RESPONSE TO SUBMISSIONS DESIGN REPORT

1 BARRACK LANE, 81-83 GEORGE ST, PARRAMATTA

APRIL 2026

CEILING HEIGHT

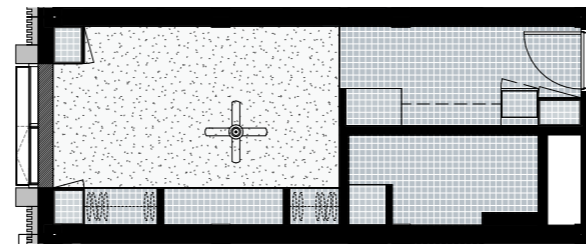
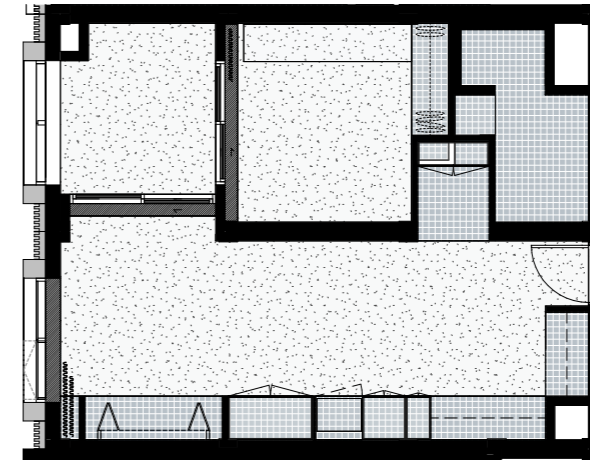
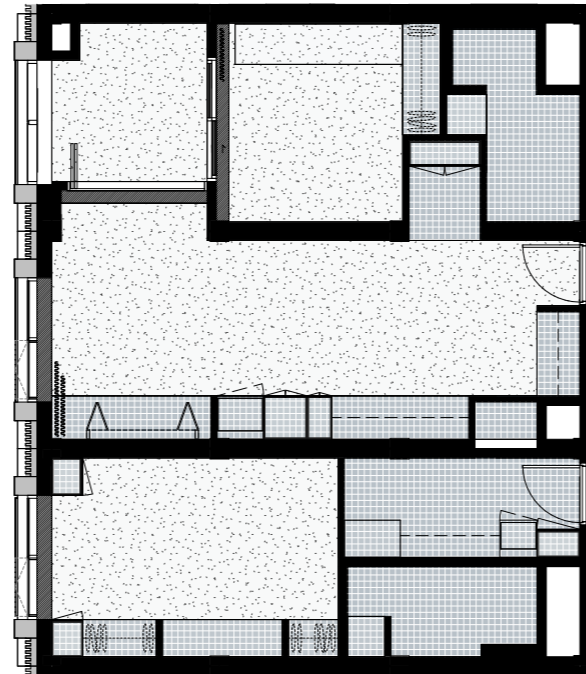
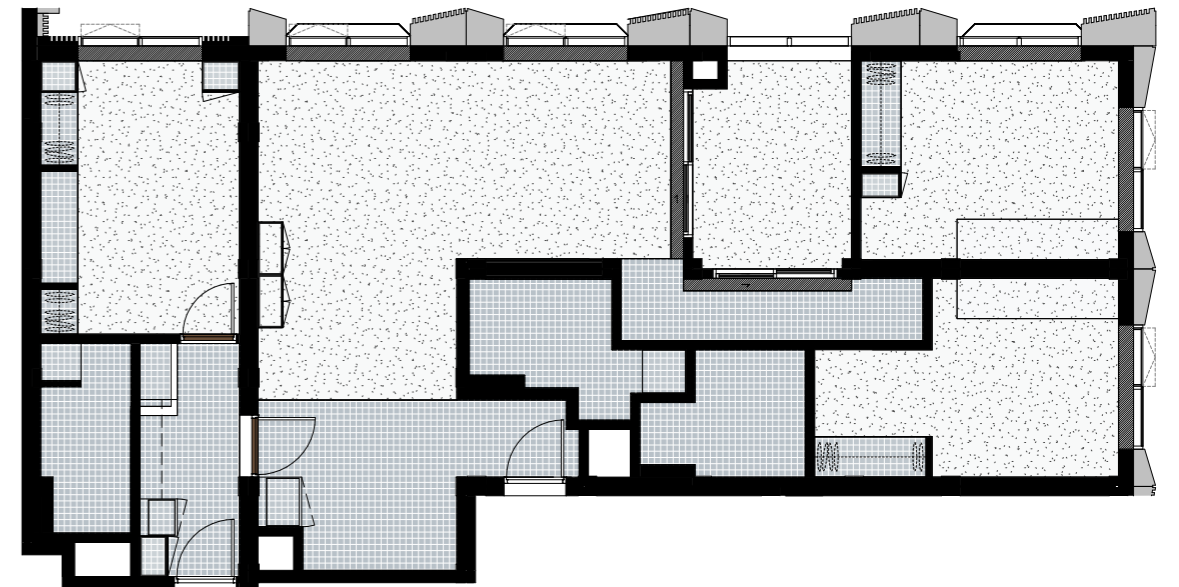
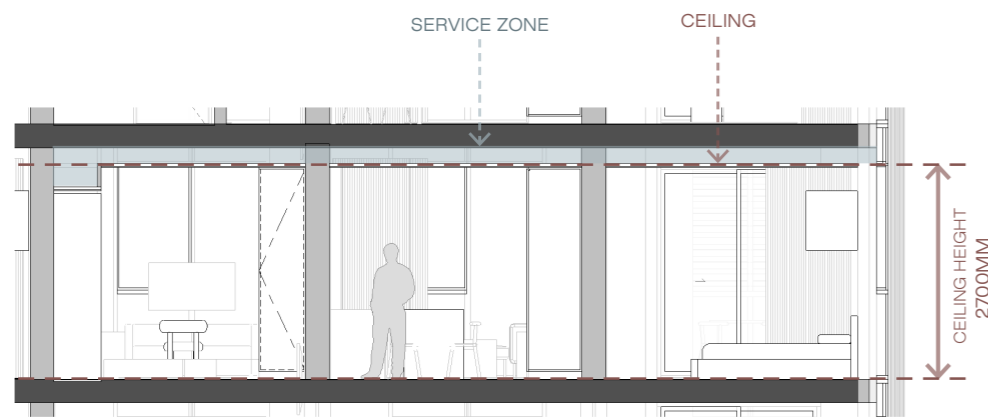
DPHI - 3
COP - 15
COP - 17

The proposed development provides compliant ceiling heights across all residential levels. Primary living areas achieve a minimum clear ceiling height of 2.7 metres, while bathrooms, kitchens and other non-habitable spaces achieve 2.4 metres.

STUDIO STORAGE

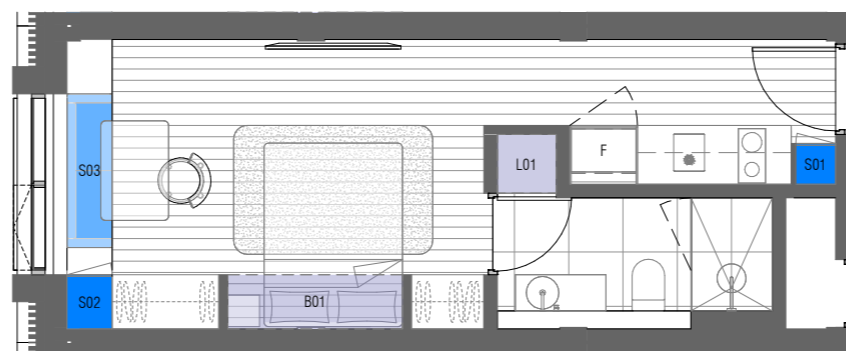
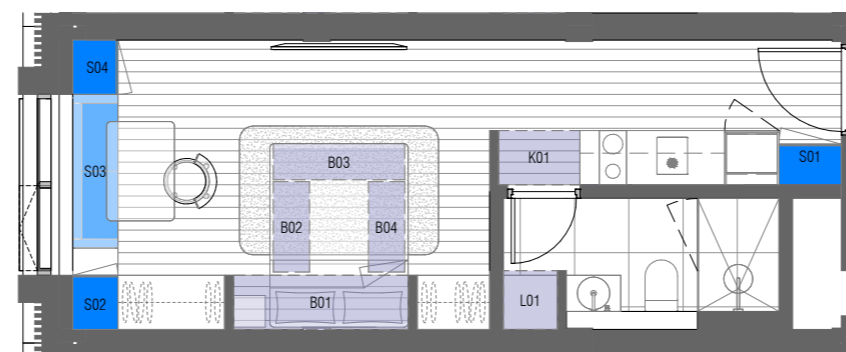
DPHI – 3
COP – 15
COP – 17

The floor plans have been further developed to increase internal storage provision across all apartment types. The revised layouts incorporate additional storage within each dwelling to improve functionality and day-to-day usability.

- SSDA ADG Storage provided – 1.14m³
- RTS ADG Storage Provided – 2.40m³
- SSDA Total in apartment storage provided – 2.49m³
- RTS Total in apartment Storage Provided – 4.21m³ (+1.72m³)

1 BED STORAGE

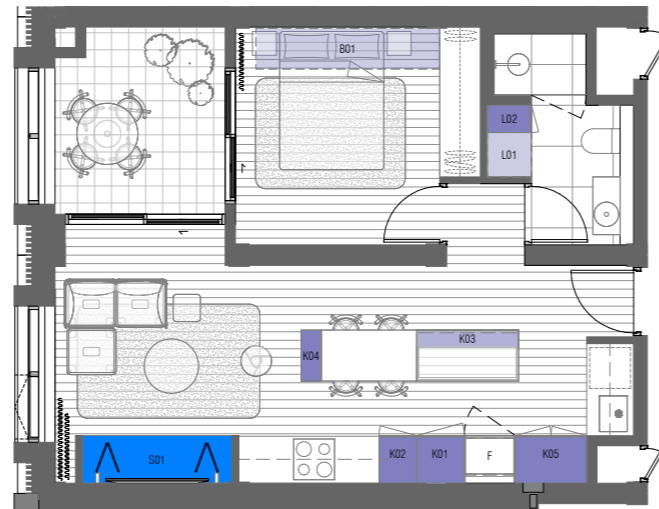
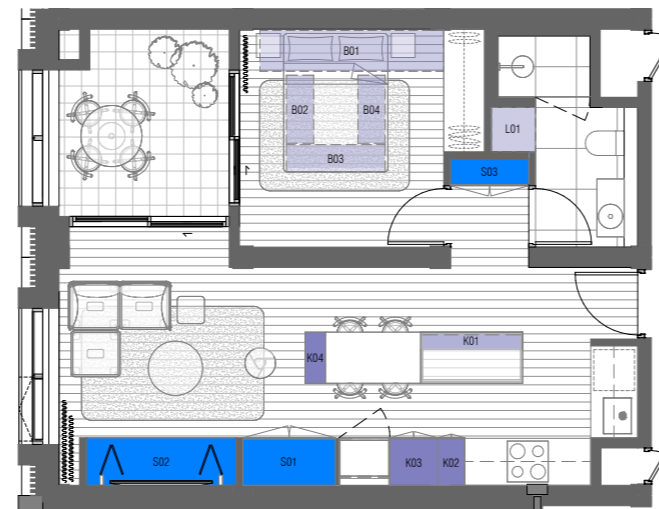
DPHI - 3
COP - 15
COP - 17

The floor plans have been further developed to increase internal storage provision across all apartment types. The revised layouts incorporate additional storage within each dwelling to improve functionality and day-to-day usability.

SSDA ADG Storage provided - 1.39m³
RTS ADG Storage Provided - 4.77m³

SSDA Total in apartment storage provided - 7.86m³
RTS Total in apartment Storage Provided - 8.65m³ (+0.79m³)

3 BED STORAGE

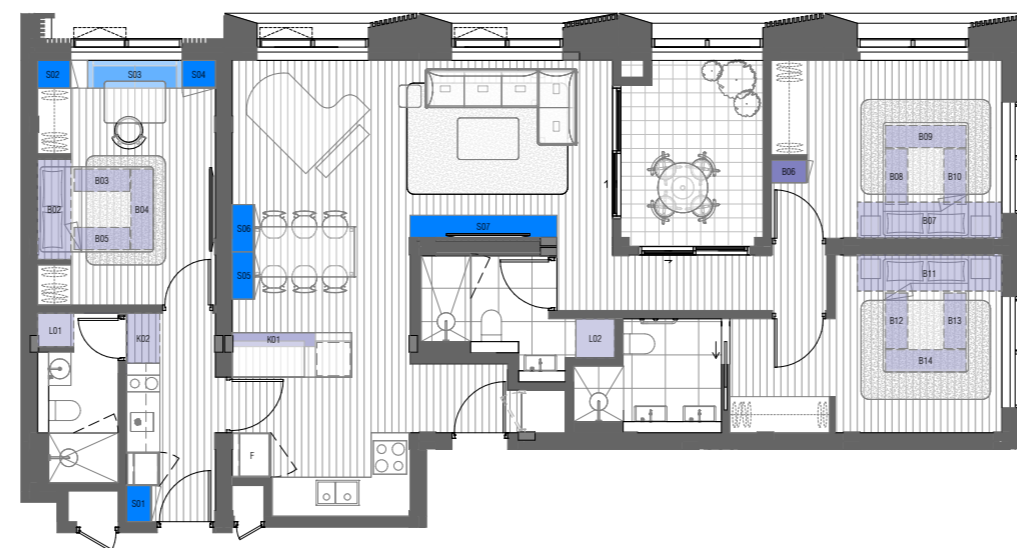
DPHI - 3
COP - 15
COP - 17

The floor plans have been further developed to increase internal storage provision across all apartment types. The revised layouts incorporate additional storage within each dwelling to improve functionality and day-to-day usability.

SSDA ADG Storage provided - 3.37m³
RTS ADG Storage Provided - 5.14m³

SSDA Total in apartment storage provided - 10.44m³
RTS Total in apartment Storage Provided - 10.58m³ (+0.14m³)

2.3 AMENITIES - GROUND FLOOR

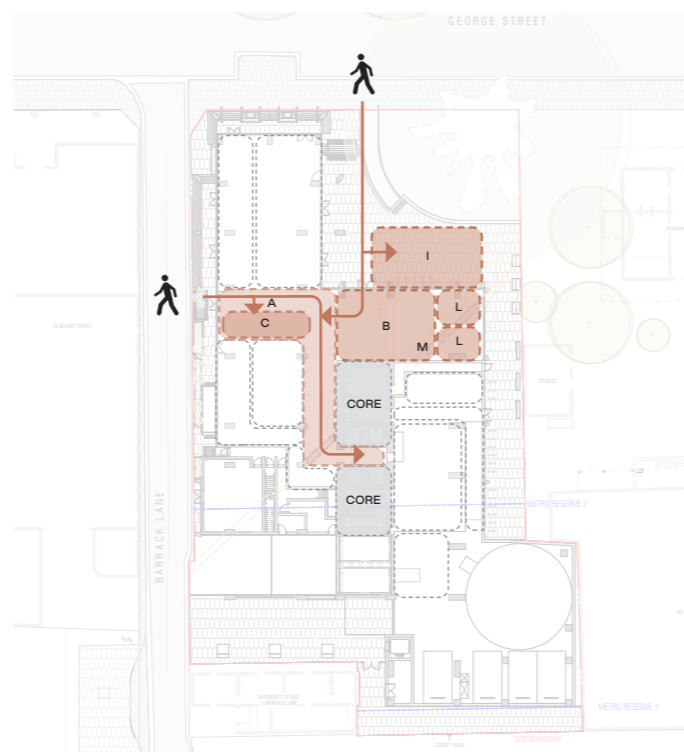
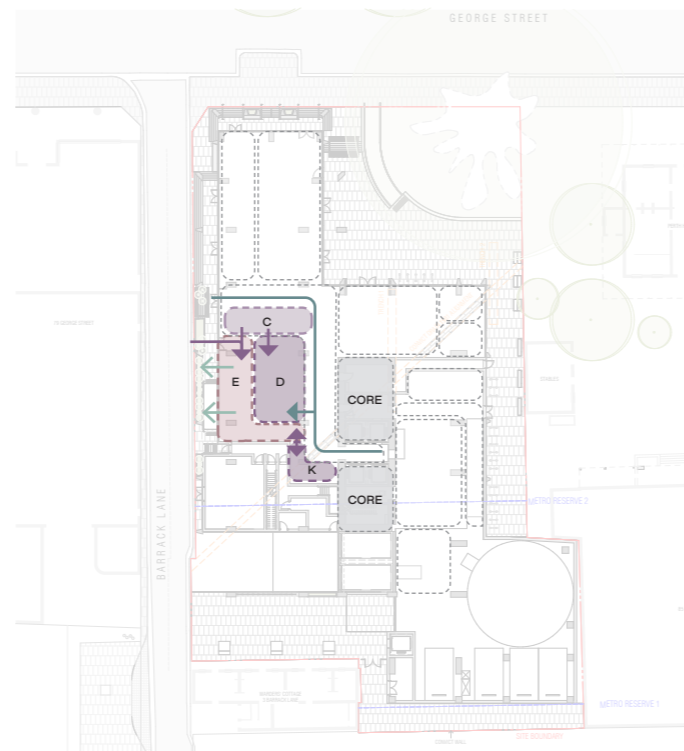
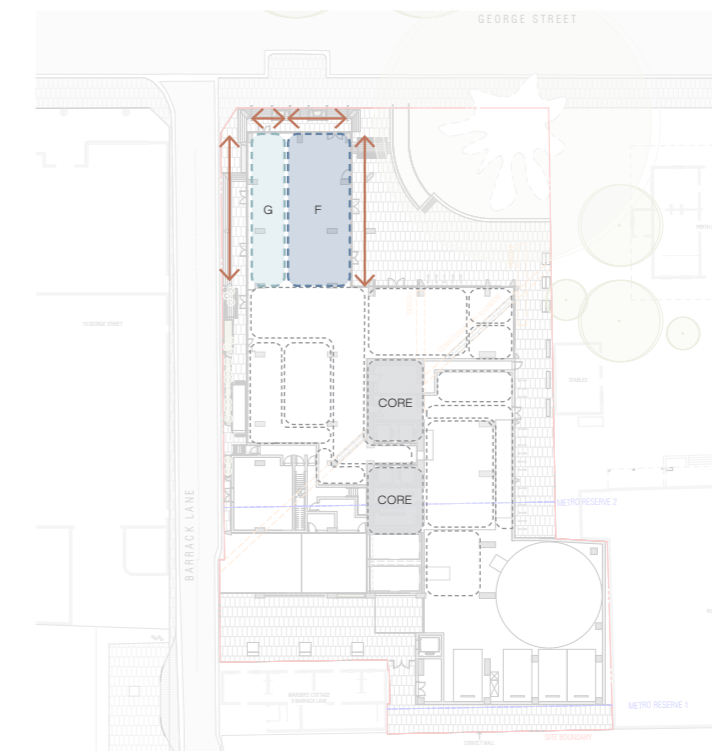
DPHI - 6

Ground floor amenity and functional planning have been further refined to improve clarity of movement, operational efficiency and interface with the public domain.

The diagrams illustrate key journey mappings, adjacencies, sightlines and retail frontages. They demonstrate resident and visitor access from **George Street and Barrack Lane**, including arrival sequences, lobby entry, waiting areas and lift access.

Building management and operational requirements have also been rationalised. The diagrams identify the adjacency of concierge, building management offices, mail and parcel facilities, and back-of-house functions to ensure efficient day-to-day operation while maintaining a clear and legible public interface.

GROUND FLOOR AMENITIES

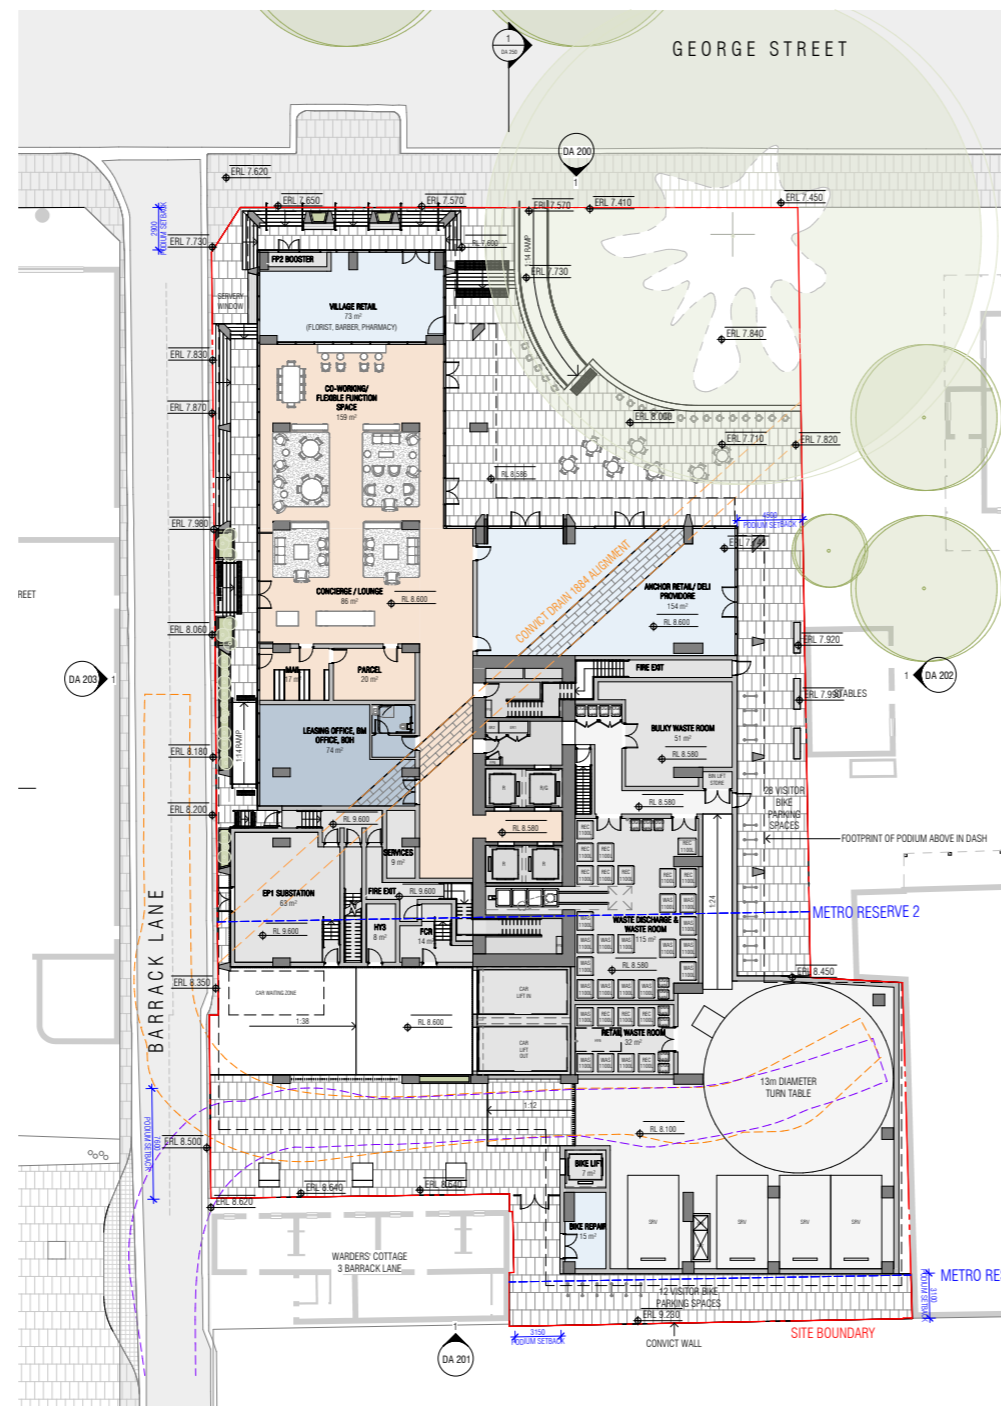
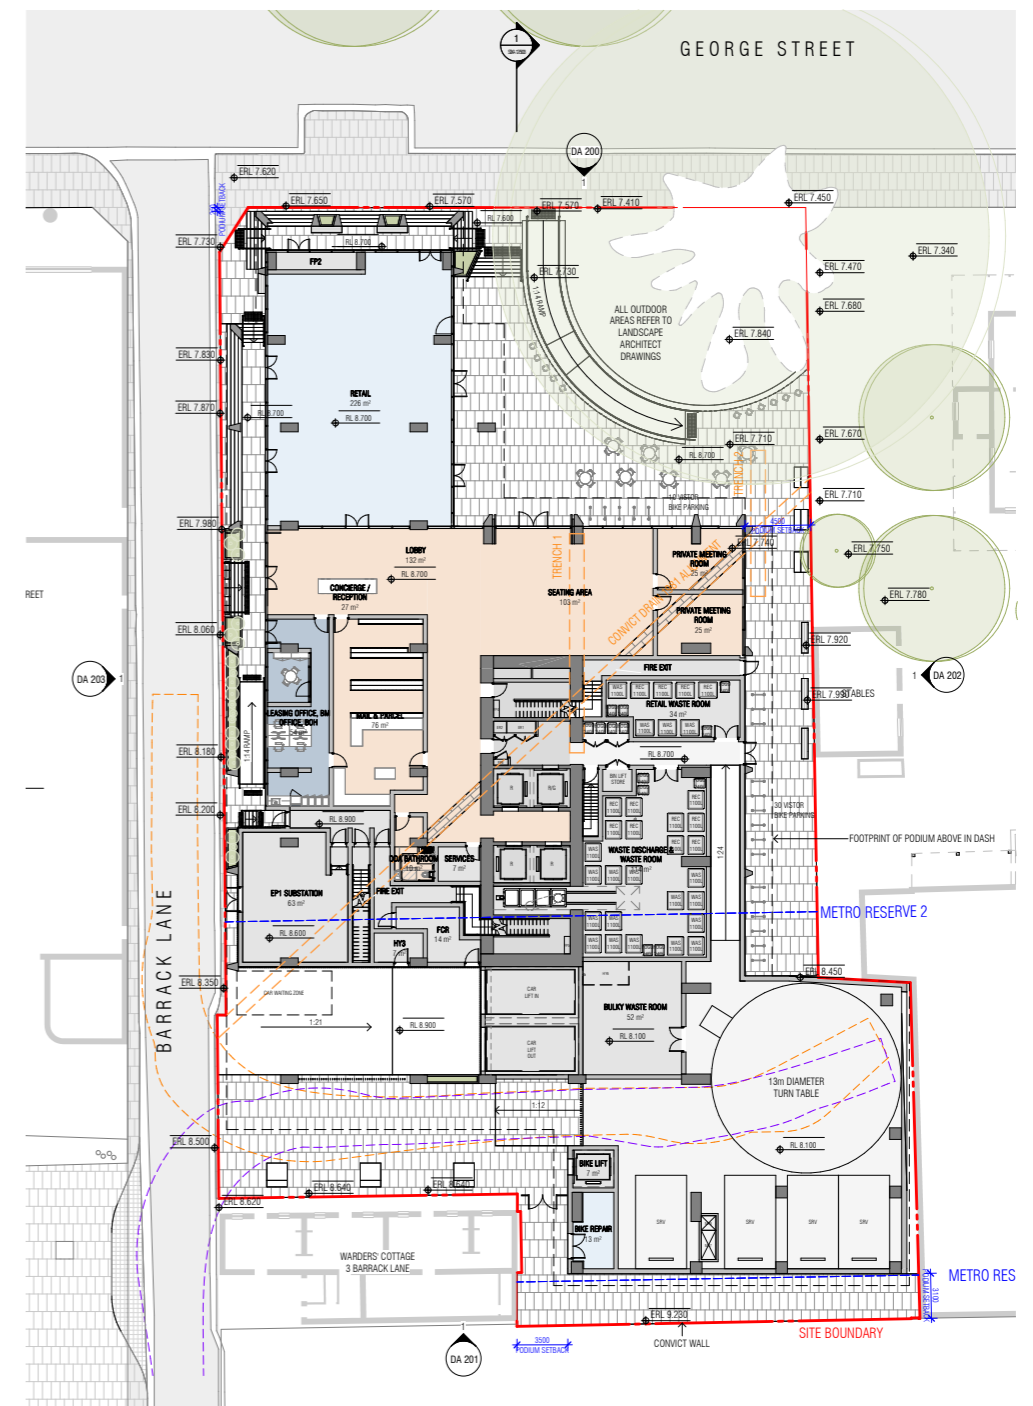
DPHI - 6

The developed ground floor plans illustrate the spatial configuration of building operations, including the residential lobby, concierge, mail and parcel facilities. The mail room has been sized to accommodate the required number of mailboxes for over 600 units, with dedicated parcel storage areas designed to manage anticipated delivery volumes.

The plans also identify the location of retail tenancies and resident private meeting room areas, demonstrating how active frontages and internal working spaces are integrated within the ground plane layout. The retail space allow further adaptation in both size and configuration, enabling a flexible tenancy arrangement that can respond to evolving operational and market requirements.
